EPA Comments on Pre-Design Investigation Work Plan, US Moorings Project Area Dated June 5, 2020

Comments dated July 14, 2020

The following are the United States Environmental Protection Agency's (EPA's) comments on the Pre-Design Investigation Work Plan (PDI WP) for the US Moorings Project Area, prepared by Anchor QEA, LLC on behalf of Northwest Natural (NWN) and dated June 5, 2020.

Mark up of Figure 3-2, Proposed Sampling Locations

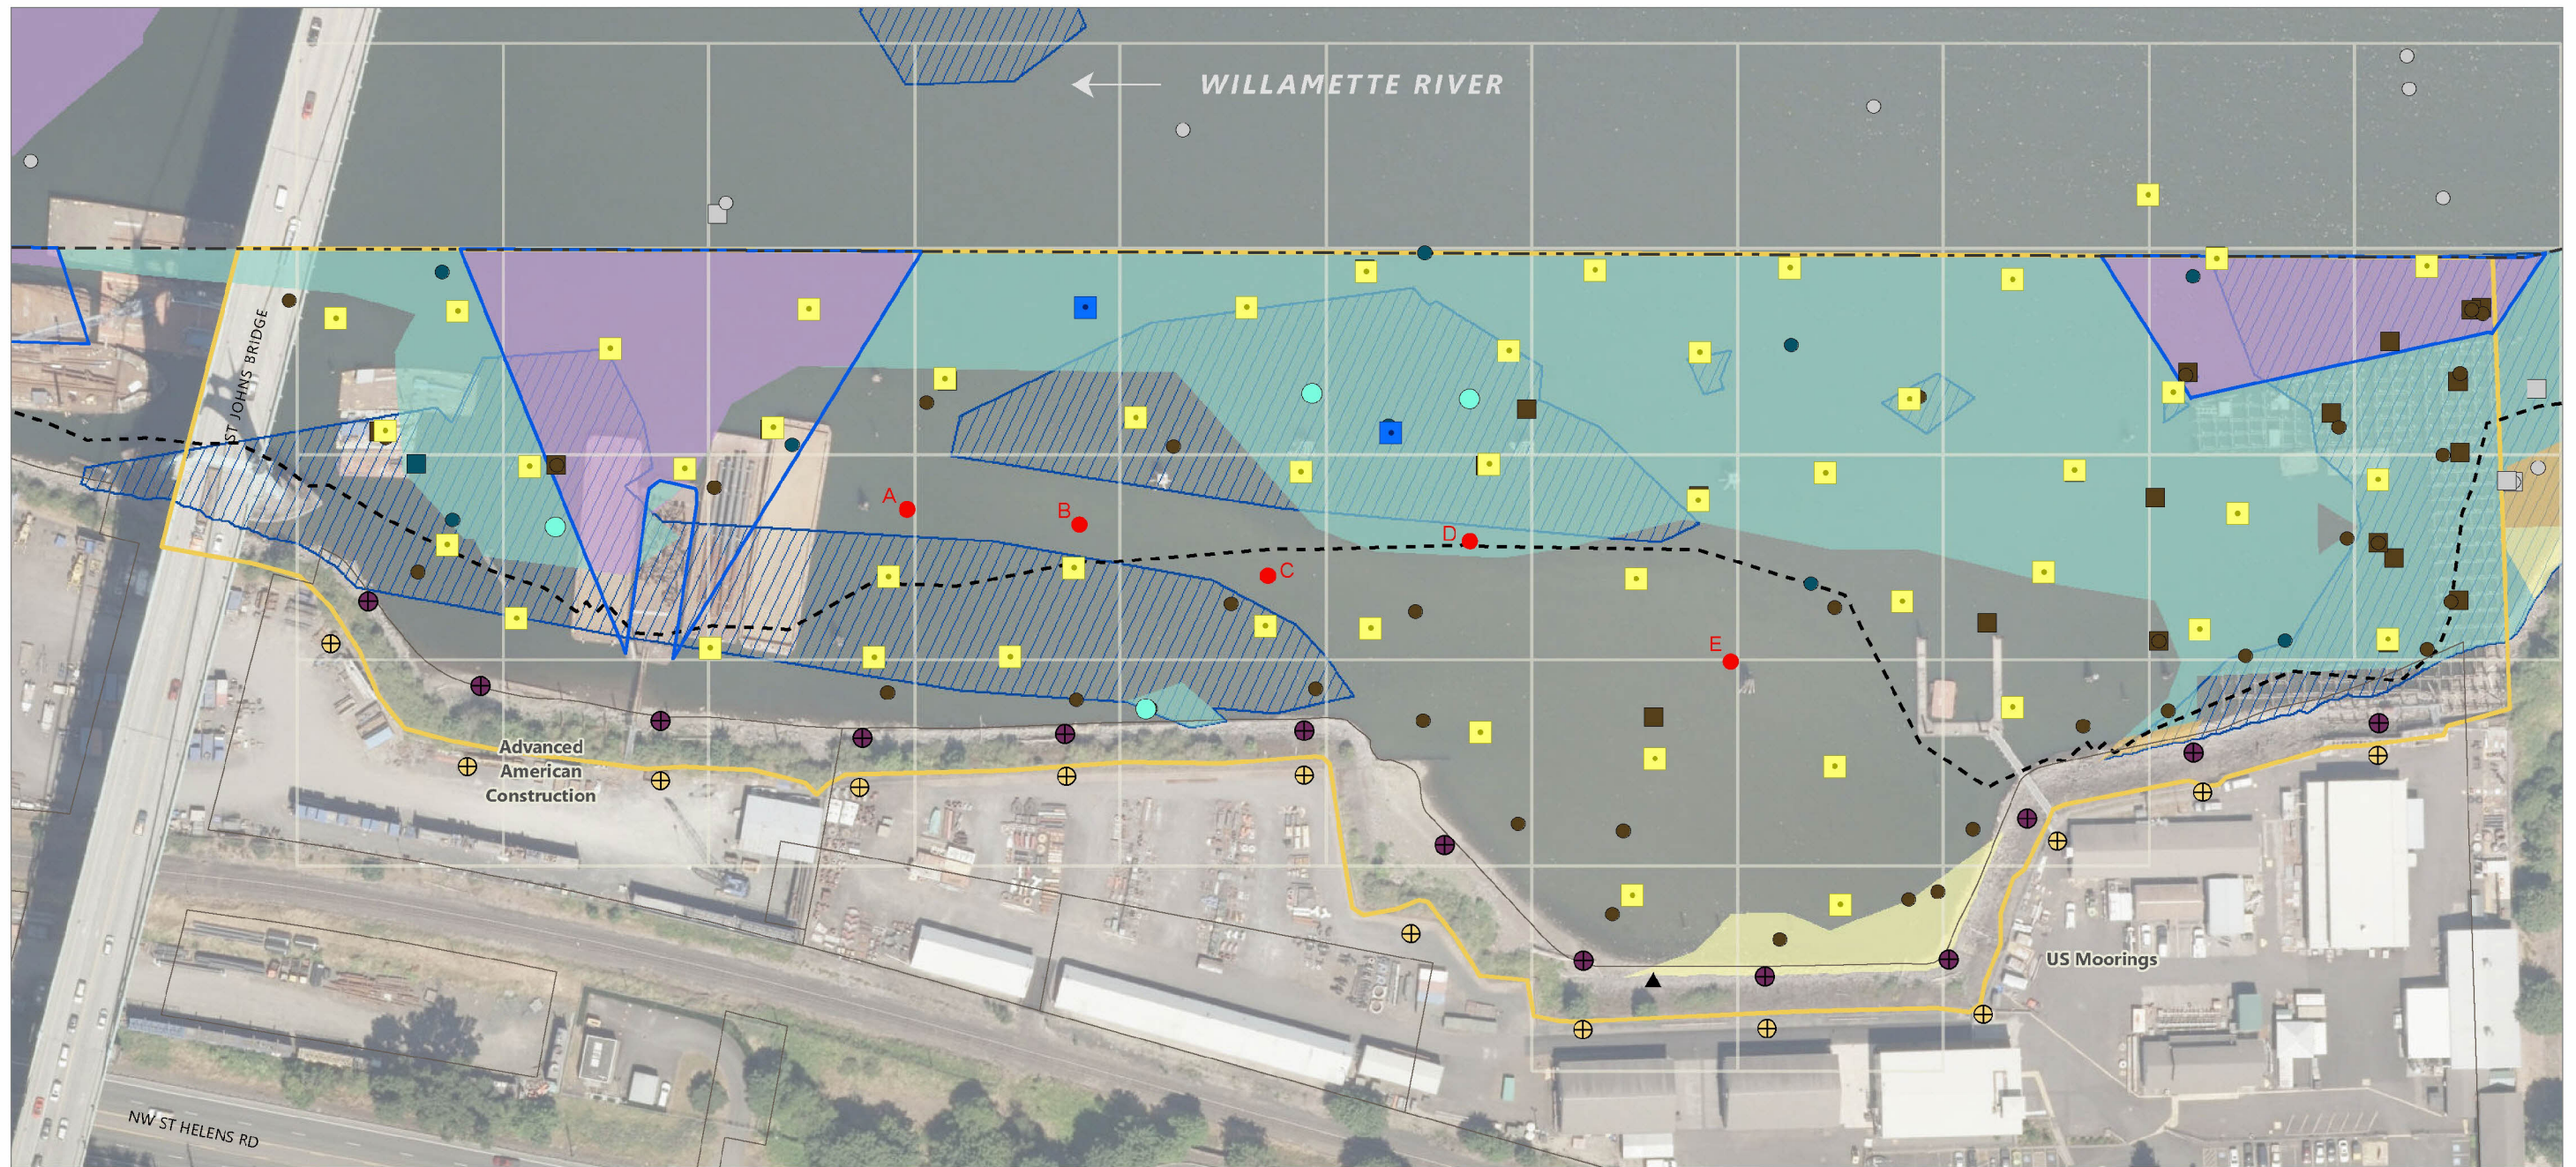
23. **Section 6.0 First Phase Pre-Design Investigation Sampling and Analysis, page 33 and Figure 3-2:** Move the proposed sample locations along the far side of the southern end of the northern SMA (i.e., SMA near and parallel to the northern half of the US Moorings Project Area shoreline) to outside the SMA boundary to fill the gap in data between the adjoining SMA.

24. **Section 6.0 First Phase Pre-Design Investigation Sampling and Analysis, page 33 and Figure 3-2:** Add the following proposed sampling locations as described below and in the attached figure.

- a. Samples A and B: Add these 2 samples or move the adjacent proposed samples inside the boundary of the northwestern SMA to these locations to address the data gaps between the two SMAs.

- b. Sample C: EPA recommends adding this sample or moving the adjacent proposed sample inside the boundary of the northwestern SMA to this location to address the data gap between the two SMAs

- c. Sample D: Include Sample D as a contingency sample based on the results of the adjacent proposed sample inside the boundary of the northeastern SMA to provide improved SMA refinement.

- d. Sample E: EPA recommends adding this sample to provide improved spatial resolution in the area (the existing samples are more than 150-ft apart).

33. **Figure 3-2 Proposed Sampling Location:** Discuss in appropriate text sections the purpose of, and data use of those samples shown in Figure 3-2 which are not co-located. The figure labels most sampling locations as “Co-located Surface and Subsurface Sediment Grab and Core (SMA Refinement, DOC, and Capping Evaluation)”. Such samples represent surface grab and subsurface core locations that address a number of data collection objectives. The figure also identifies a small number of separate samples as “Surface Sediment Grab (SMA Refinement)” and “Subsurface Sediment Core (DOC and Capping Evaluation).”
